STATEMENT OF ENVIRONMENTAL EFFECTS

**SECTION 4.56 APPLICATION TO MODIFY CONSENT GRANTED TO
DEVELOPMENT APPLICATION DA2021/1408 FOR DEMOLITION OF EXISTING
DETACHED DWELLING AND ERECTION OF A PART 2/PART 3-STOREY
DETACHED DWELLING, CARPORT, BOATSHED, SITE WORKS AND
LANDSCAPING**

**16 ADDISON ROAD
MANLY**

**Prepared by
KN Planning Pty Limited**

SITE PLAN 1:100

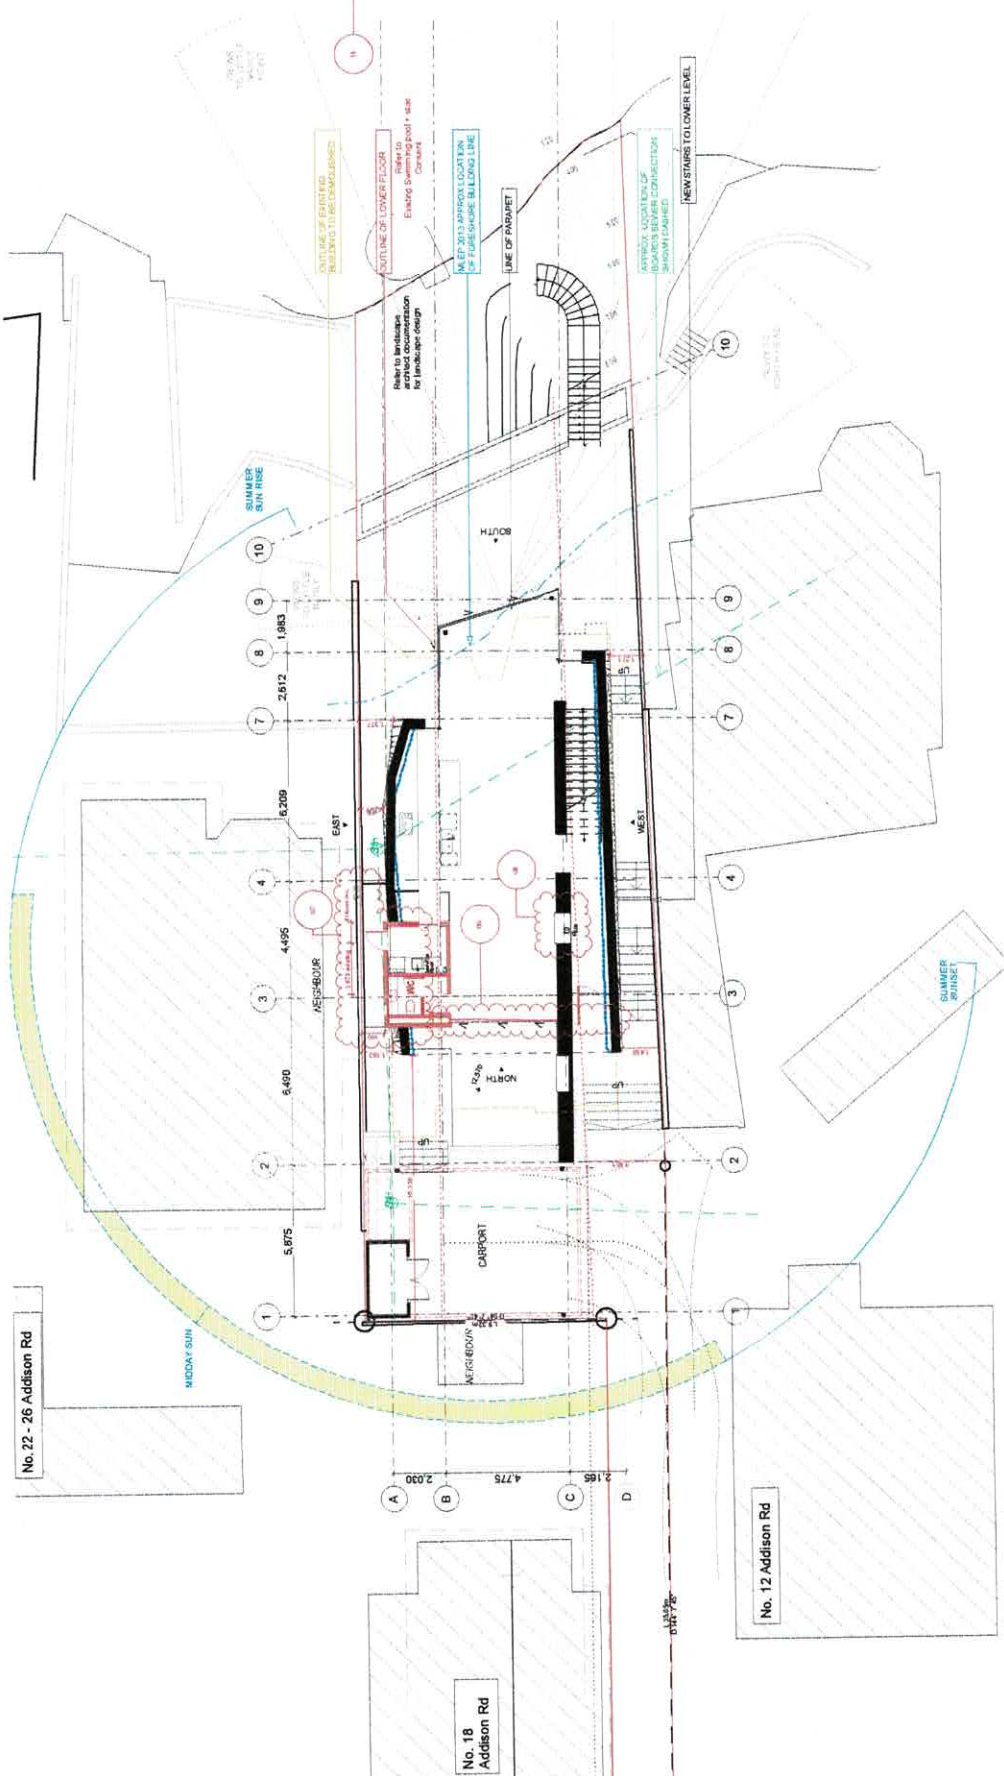
- 06. The sliding glazed doors accessing the north terrace have been moved approx. 1.0m to allow for a WC on the ground floor. The front door was moved to align with the sliding doors.
- 07. The metal clad wall on grid A was extended to the north to provide additional area for the WC. Opaque glass window added.
- 08. Approved internal gas fireplace replaced with solid fuel fireplace in same location
- 16. GFA increased from 313m² to 317.38m².

BOAT SHED PLAN 1:50

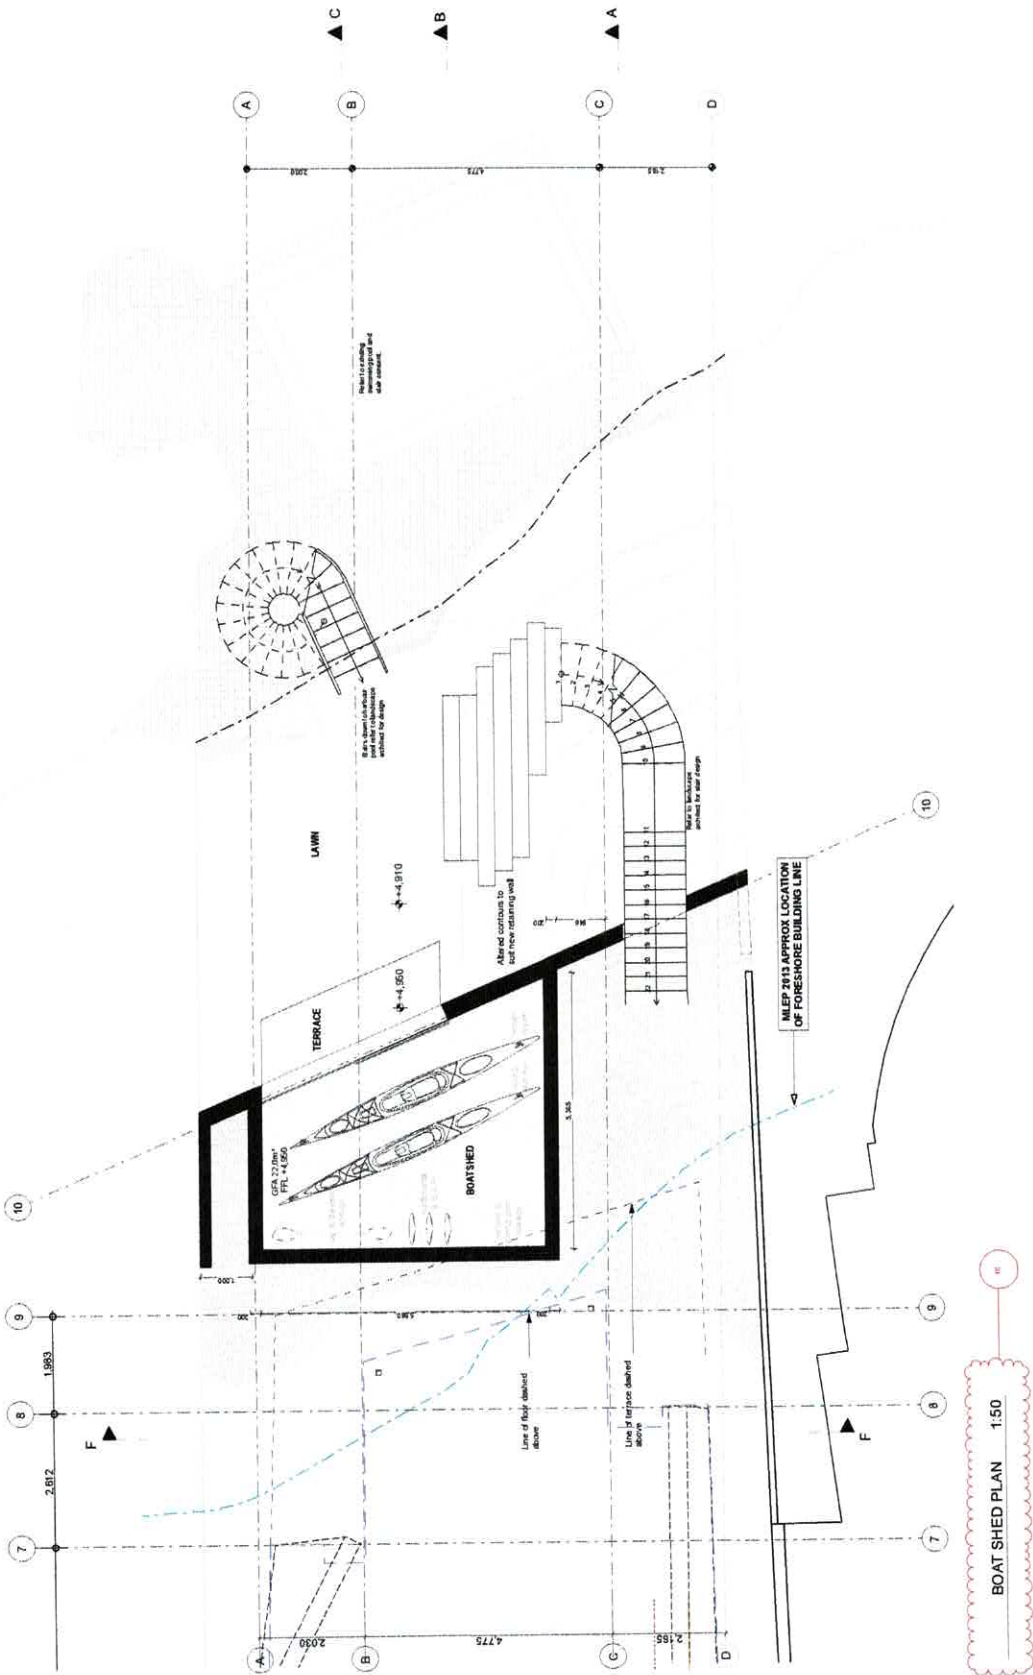
- 01. No change to boatshed and landscaped foreshore areas.

LOWER FLOOR PLAN 1:50

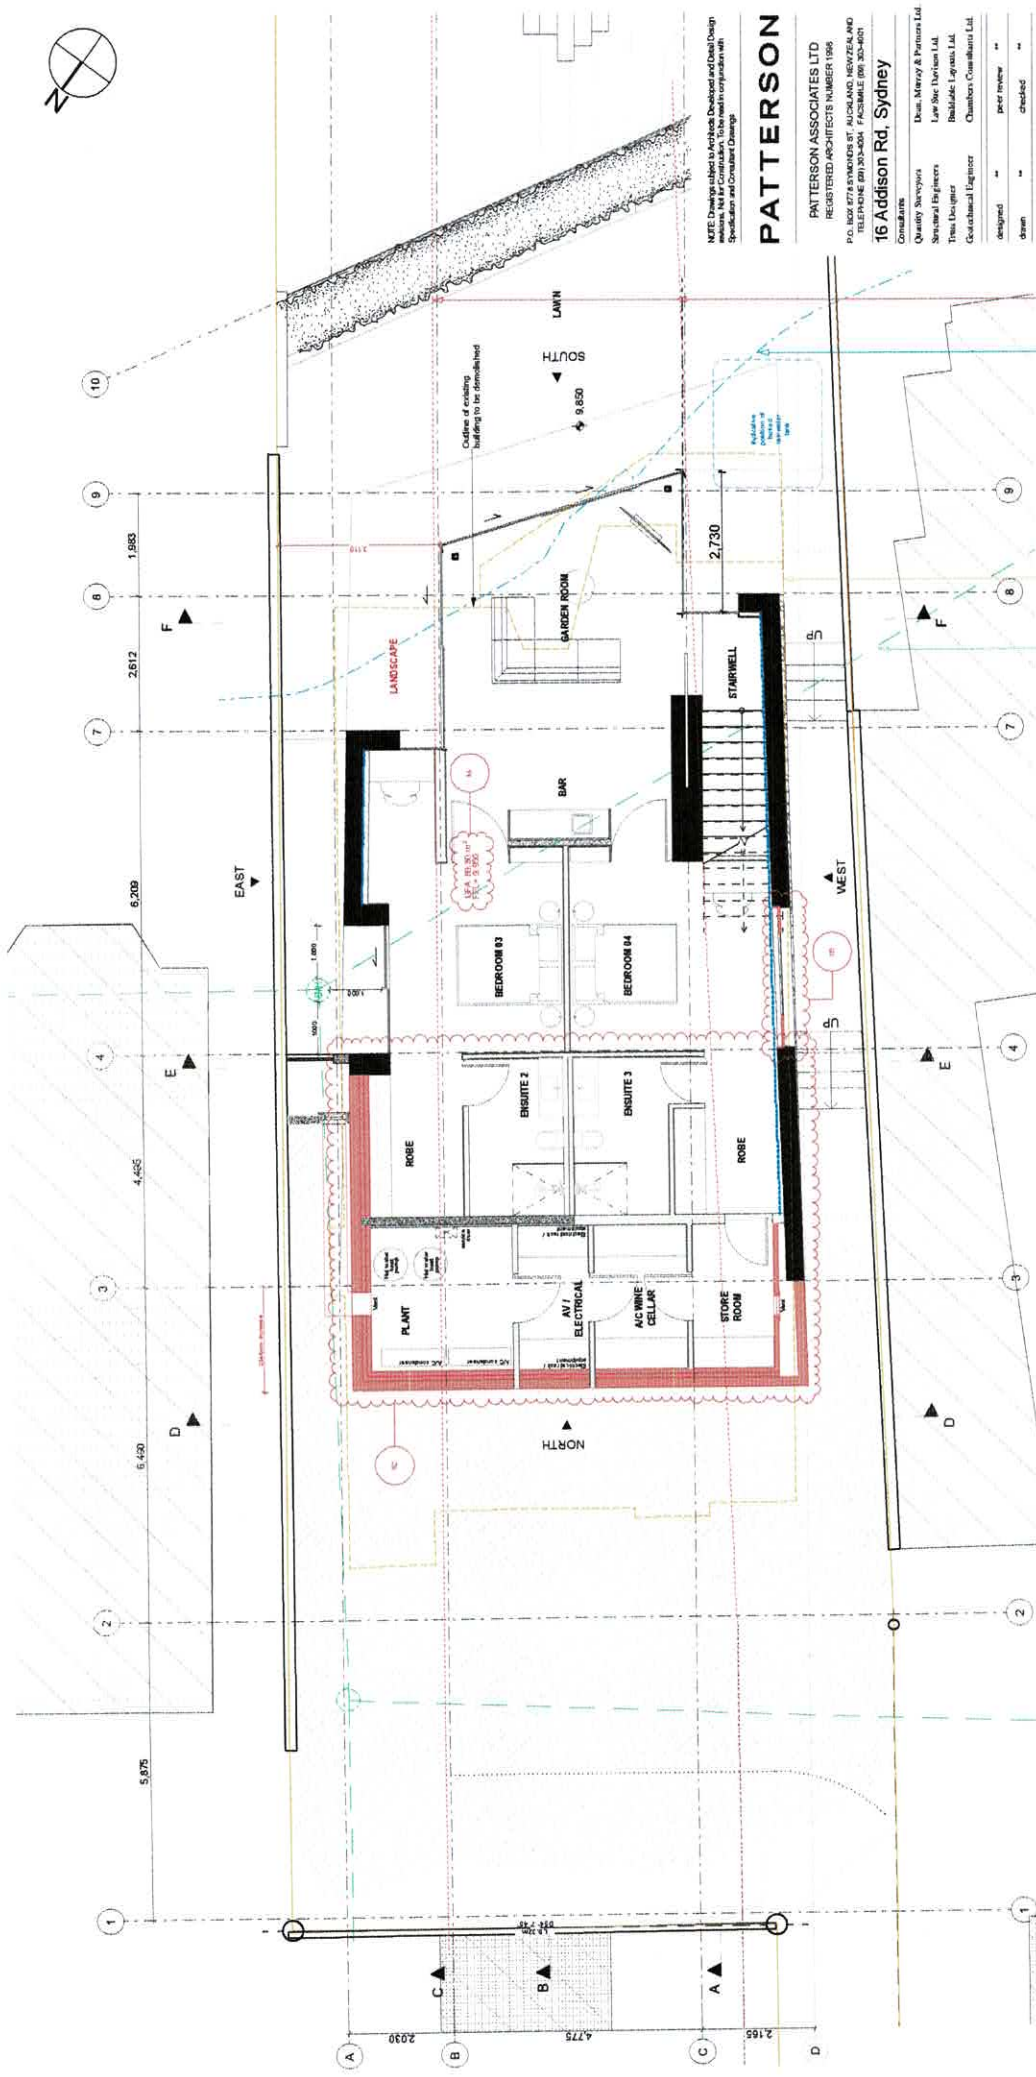
- 02. Basement excavation extended to 2046 mm to the north to allow for additional plan equipment & store area, ensuite layout altered.
- 03. Window to bedroom 04 in western façade increased in length by 1.0m and 0.5m in height
- 16. GFA increased from 84.3m² to 89.8m²

GROUND FLOOR PLAN 1:100

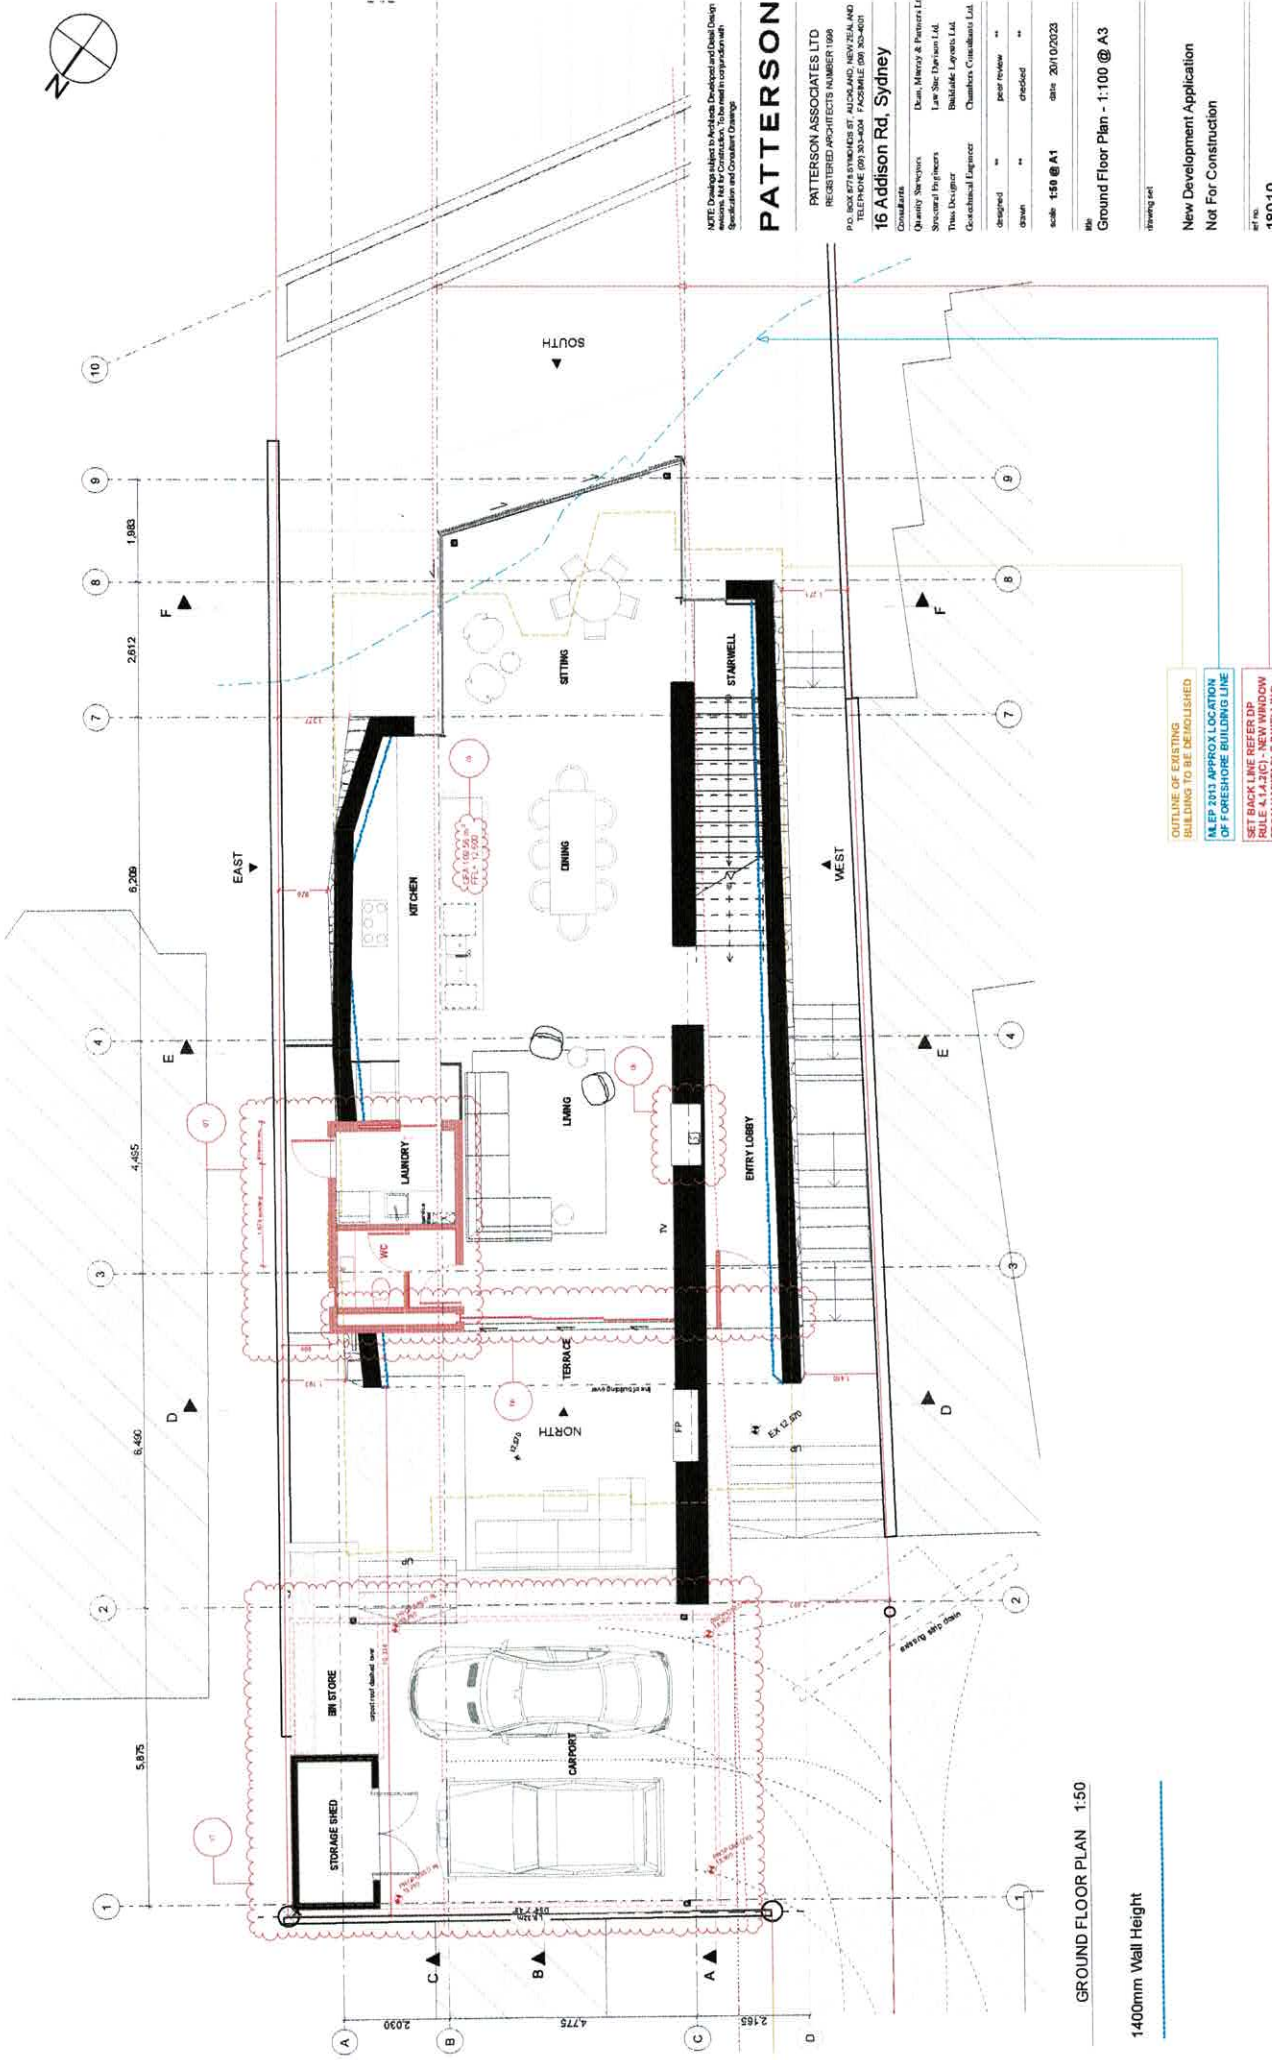
- 06. The sliding glazed doors accessing the north terrace have been moved approx. 1.0m north to allow for a WC on the ground floor. The front door was moved to align with the sliding door.
- 07. The metal clad wall on grid A was extended to the north to provide additional area for the WC. Opaque glass window added.
- 08. Approved internal gas fireplace replaced with solid fuel fireplace in same location.
- 16. GFA increased from 106.4m² to 109.56m²
- 17. Carport slab level raised slightly to allow for existing drainage serviced and boundary fencing

FIRST FLOOR PLAN 1:50

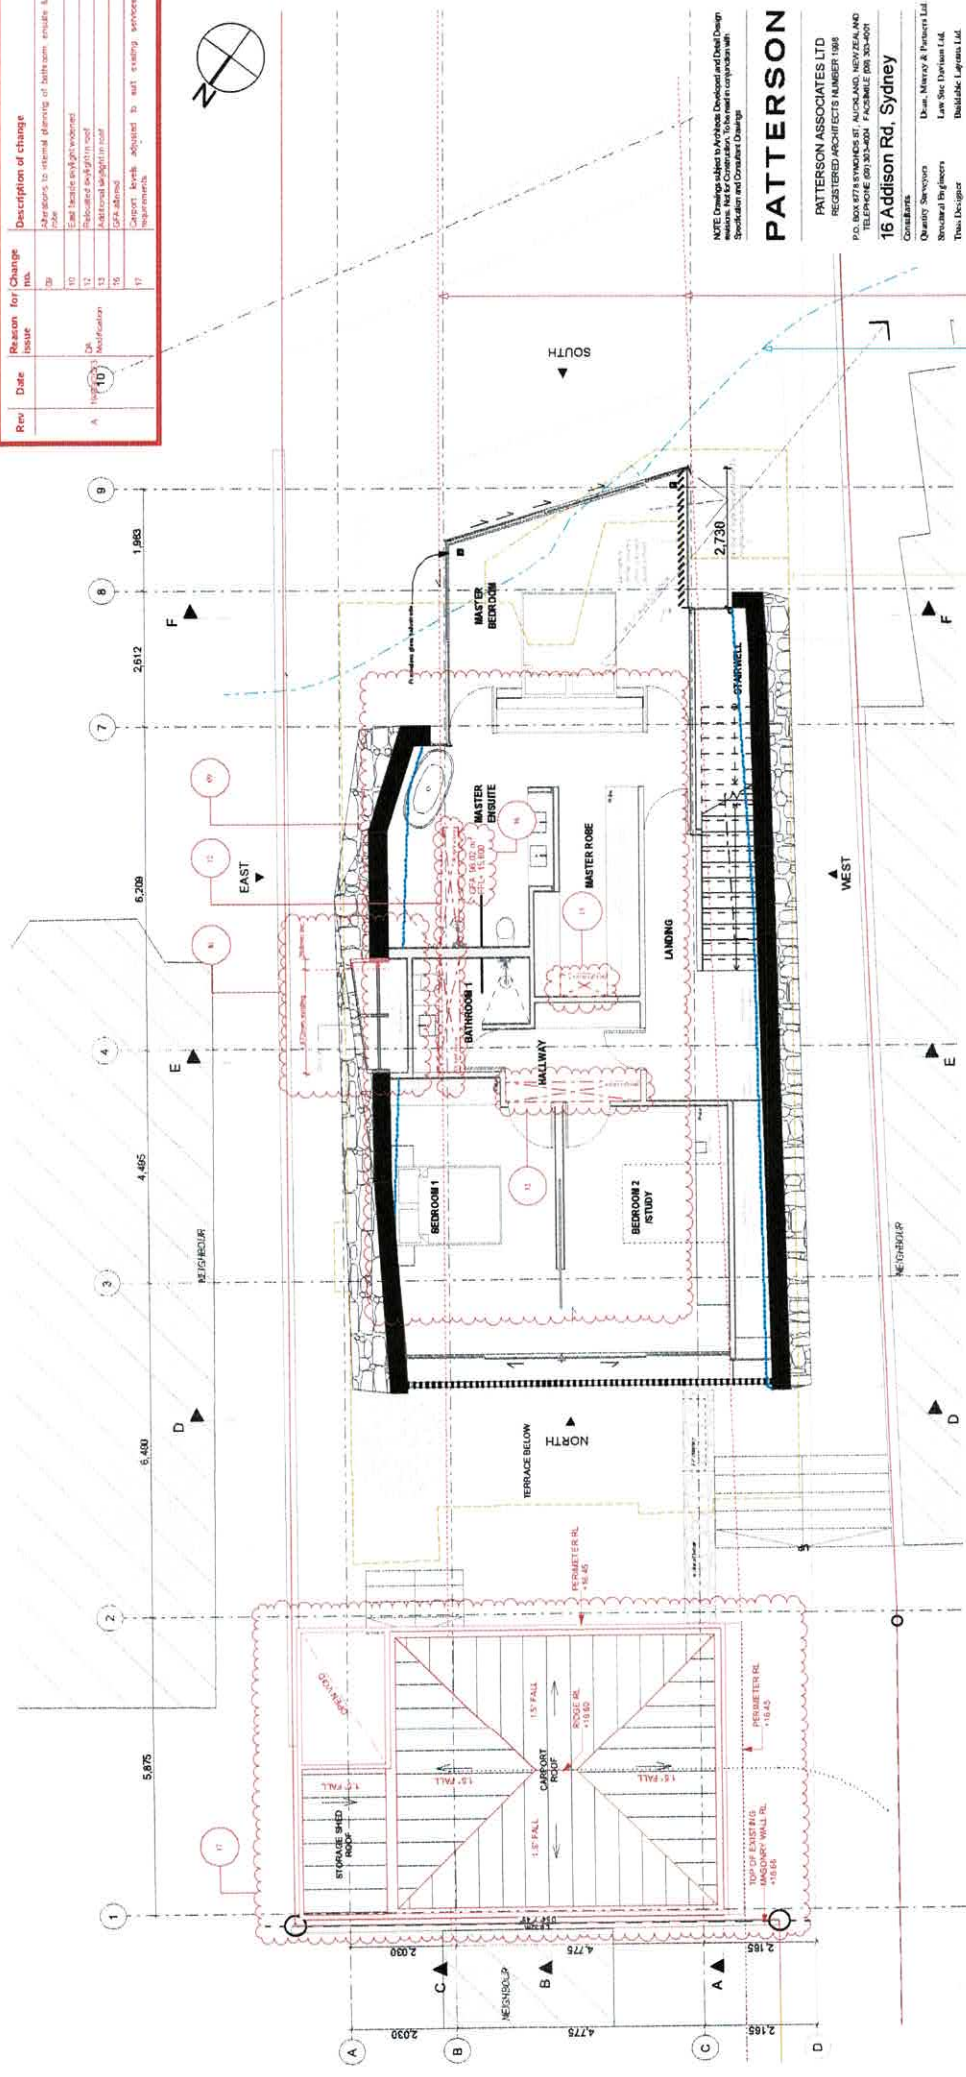
- 09. Alterations to internal planning of bathroom, ensuite & robe.
- 10. East facade skylight widened by approximately 200mm.
- 12. Relocated skylight in roof over master ensuite bathroom 1 and hallway.
- 13. Additional skylight in roof added over master robe.
- 16. GFA reduced from 100.3m² to 96.02 m² accounting for the increased lightwell area and the sloping walls correctly measured at 1.4m above floor level.
- 17. Carport roof level raised slightly to match height of adjoining boundary wall to allow adequate height clearance from slab level.
